September 8, 2009  
U7-C-STP-NRC-090131

South Texas Project  
Units 3 and 4  
Docket Nos. 52-012 and 52-013  
Response to Request for Additional Information

Attached are the responses to the NRC staff questions included in Request for Additional Information (RAI) letter numbers 129, 212 and 215, related to Combined License Application (COLA) Part 2, Tier 2, Chapters 8, Electric Power, 14, Initial Test Program and 16, Technical Specifications. This submittal completes the response to RAI letter numbers 129 and 212.

FIGURE B-3-1 ELECTRICAL POWER DISTRIBUTION SYSTEM SINGLE LINE DIAGRAM (SHEET 4 OF 4)

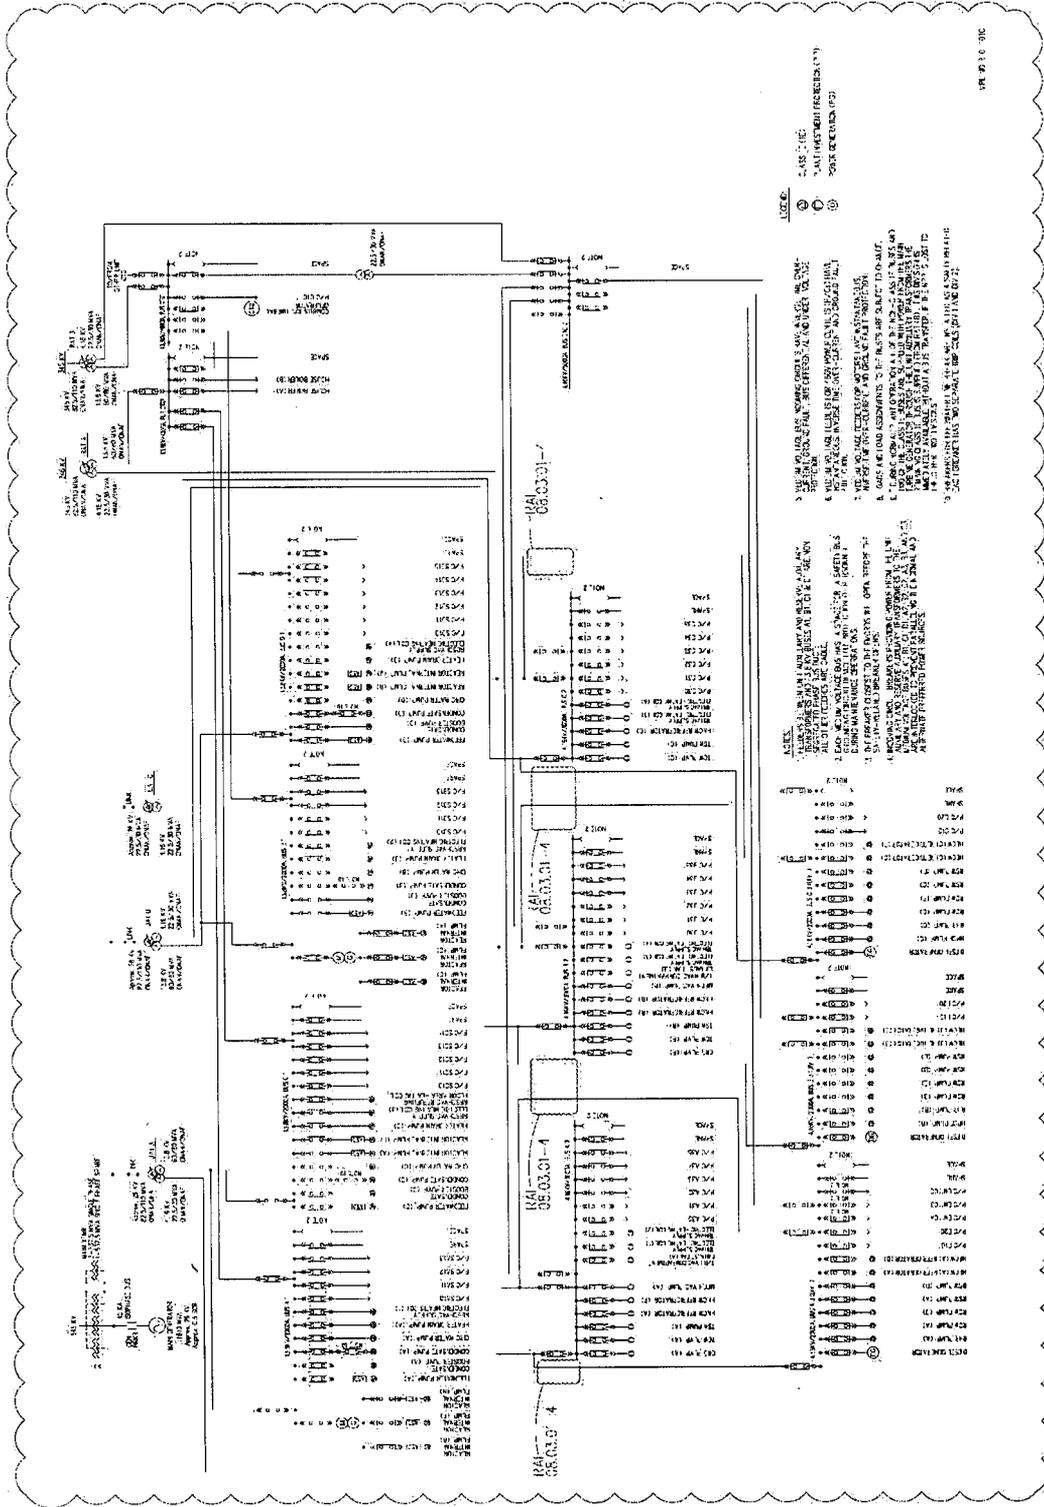
STP Letter U7-C-STP-NRC-090071 (ML092190534), dated July 22, 2009, provided the response to RAI question 08.03.01-4, which included changes to STP COLA Part 2, Tier 2, Chapters 7 and 8 that reduced the number of non-Class 1E buses between the UATs and RAT A and the Class 1E buses. The response to RAI question 08.03.01-4 stated that “FSAR Figure 8.3-1, Sheet 1, Figure 8.21 Sheet 1, and Figure 7.4-2 will also change as a result of the stub bus removal.” This supplemental response provides FSAR Figure 8.3-1, Sheet 1, and FSAR Figure 7.4-2. Figure 8.2-1, Sheet 1, “Power Distribution Routing Diagram,” is a plant layout drawing that will be provided in a future update to the COLA.
